Techn. Customer Service VKT-20	Motorcycle R 50/5, R 60/5, R 75/5 Group: electricity	Munich, Nov. 70 No. 2/70 (287) eng.
-----------------------------------	---	--

RE: Blinker control

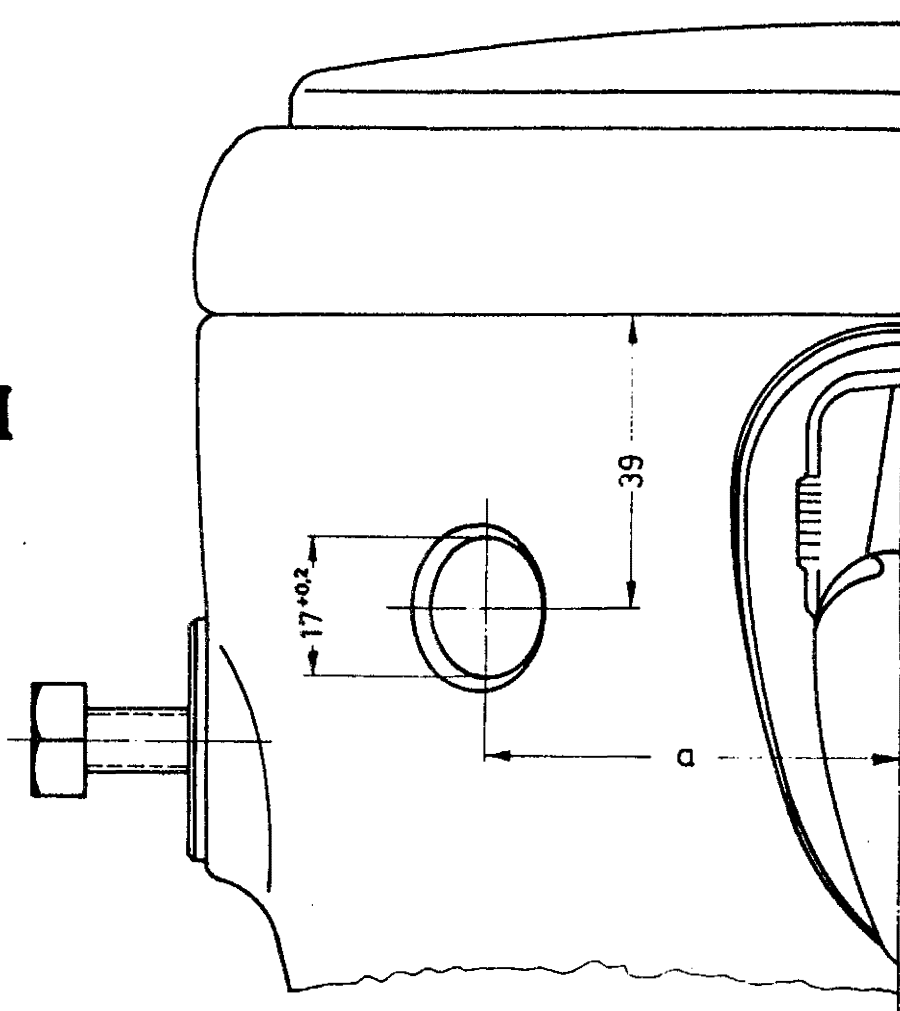
following a customer demand we fitted a blinker control as from

type R 50/5 chassis No. 2 901 379
 type R 60/5 chassis No. 2 932 142
 type R 75/5 chassis No. 2 972 388

The blinker control light is in driving direction left nearby the ignition and light switch in the headlamp and consists from the following parts

The blinker control can be also re-fitted against facturation. Make the bore 17 + 0,2 mm dia. following chart I, a = 55 mm, should be taken from the imaginary middle line of the headlamp with a circle.

Contact the lines following chart II.
In chart II

pos. 1 means	control lamp
pos. 2 means	blinker sender
pos. 3 means	connection.
